41502329 - WASHINGTON ISLAND JACKSON HARBOR

Sanitary Survey Checklist

RE: Variance Approval For The Well #YG919 Serving The Property Located At 1902 Jackson Harbor Road t,
Town Of Washington (T34N, R30E, S28, SE, NW,) Door County, Wisconsin

Figure 41. Overflow piping arrangement for a flowing well with a submersible pump.

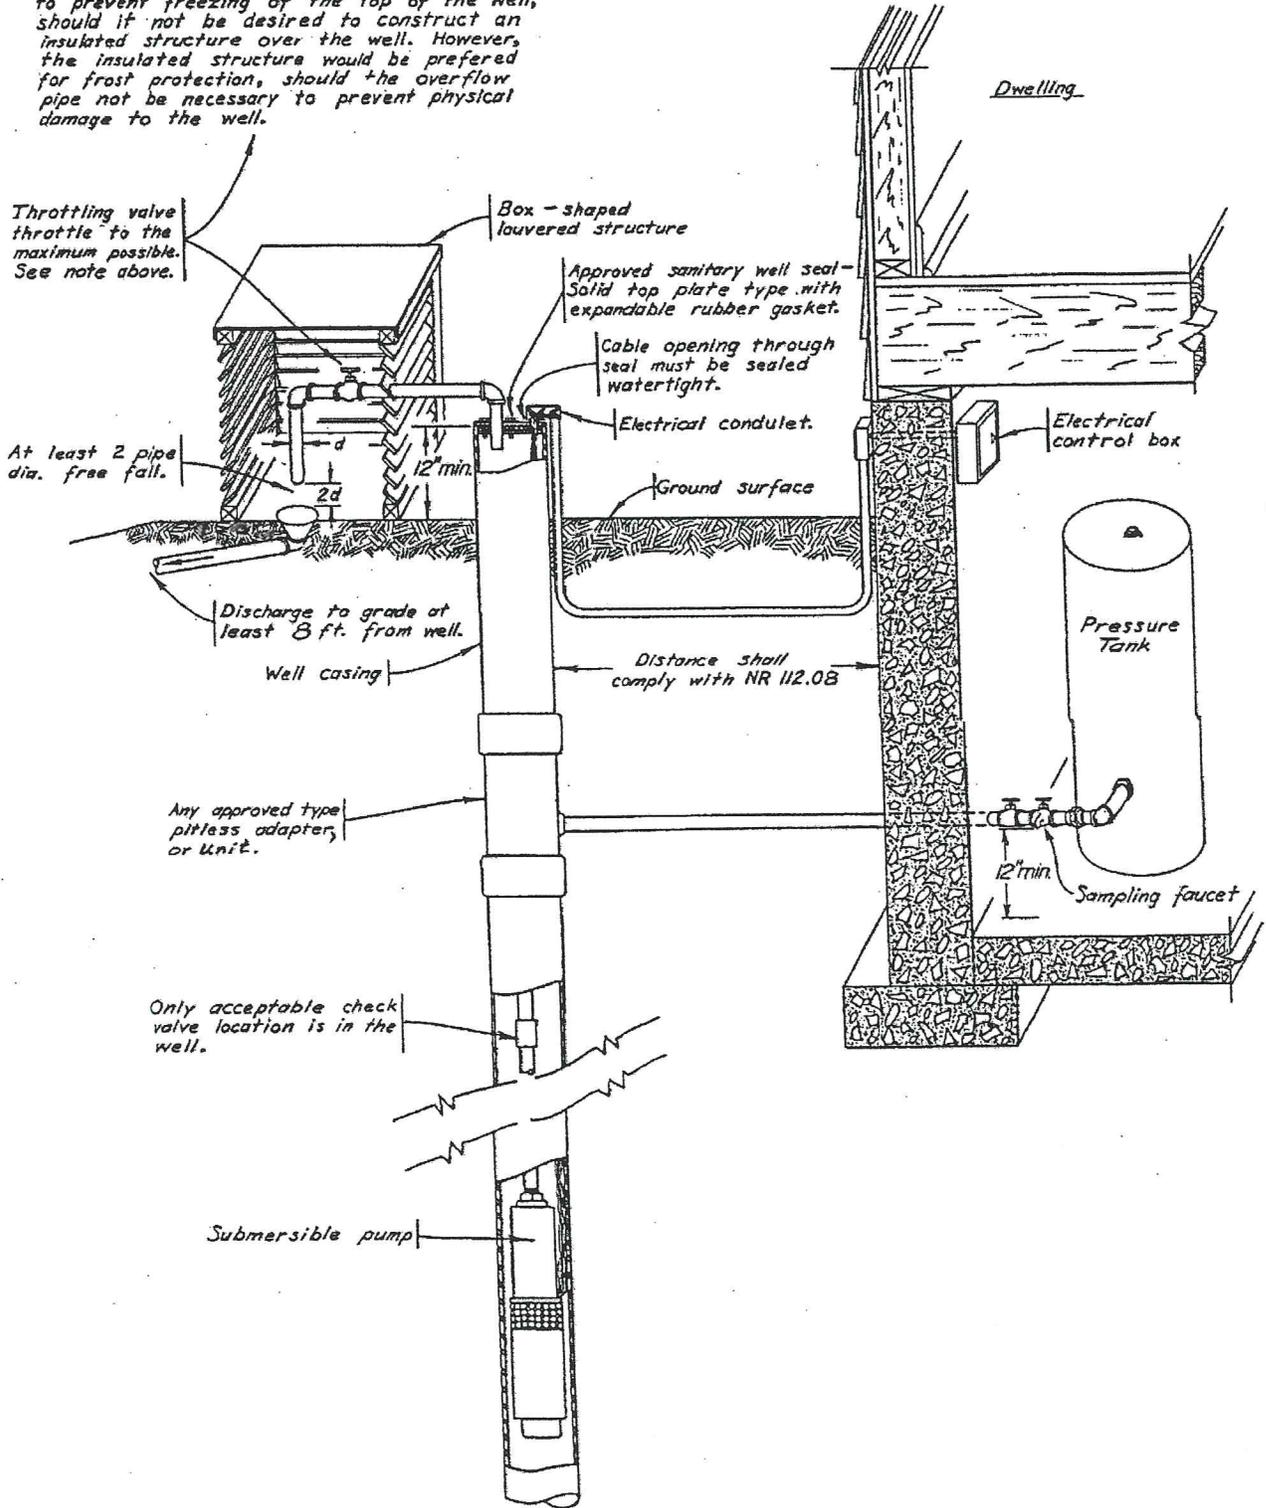
3. Overflow to prevent freezing shall be limited to a minimum to preserve groundwater and water pressure. The **overflow pipe shall be installed** to extend at least **12 inches** above ground grade or shall extend from a surge tank. The overflow pipe shall terminate at least 2 pipe diameters above any drain at the well site, building or building basement. If the overflow is installed at the well, an air gap of at least 2 pipe diameters shall be provided at the well and the receiving drain shall discharge to the ground or to a gravel pocket at a point at least 8 feet from the well. A funnel receptacle shall be installed on the inlet of the drain to accept all of the overflow water, to prevent splashing and to prevent pending of water around the well casing pipe.

Install overflow pipe with throttle valve, screen, and drain.

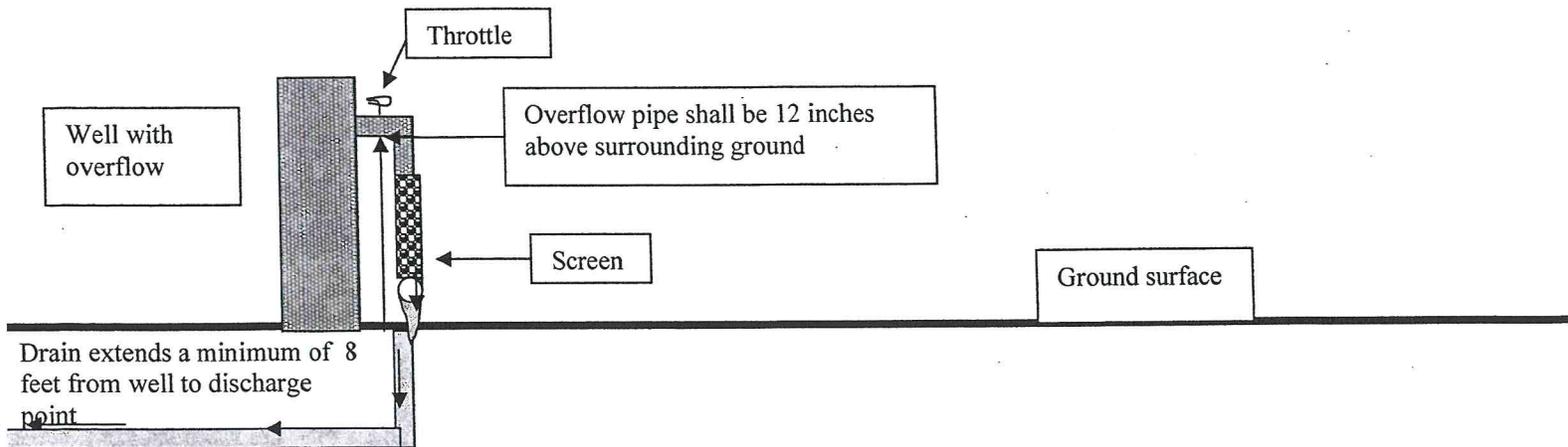
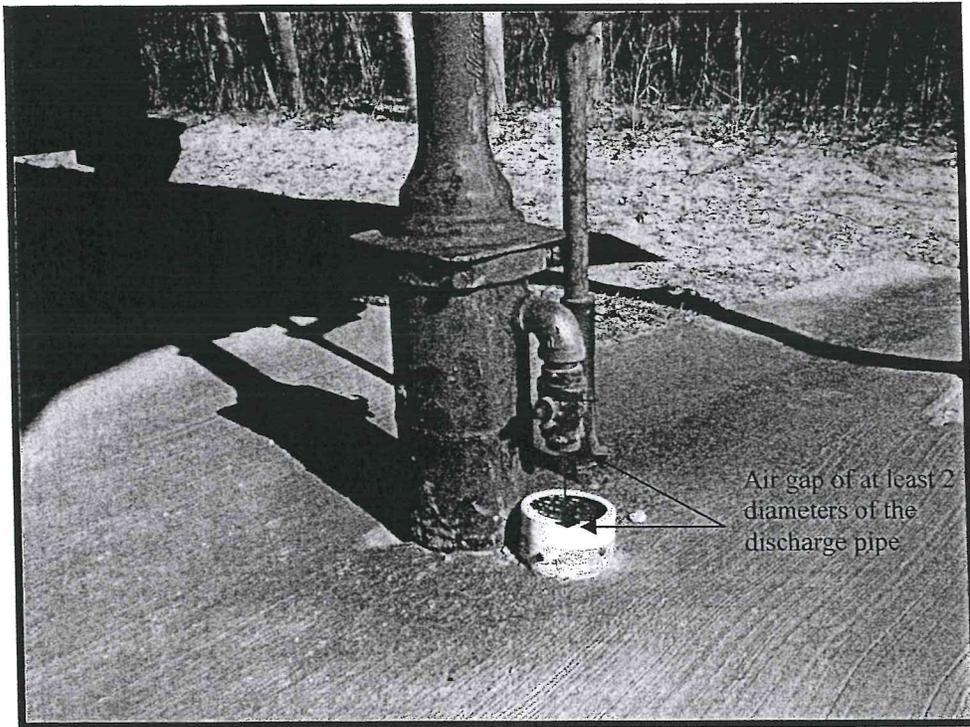
The above diagram includes a screen from the overflow pipe to the drain. The screen would be attached at the overflow pipe and at the entrance to the drain. The screen would provide the air gap so suction doesn't occur. The screen area would need to be a minimum length of 2 diameters of the width of the discharge pipe. Screening will prevent the drain from getting clogged and keep out vermin.
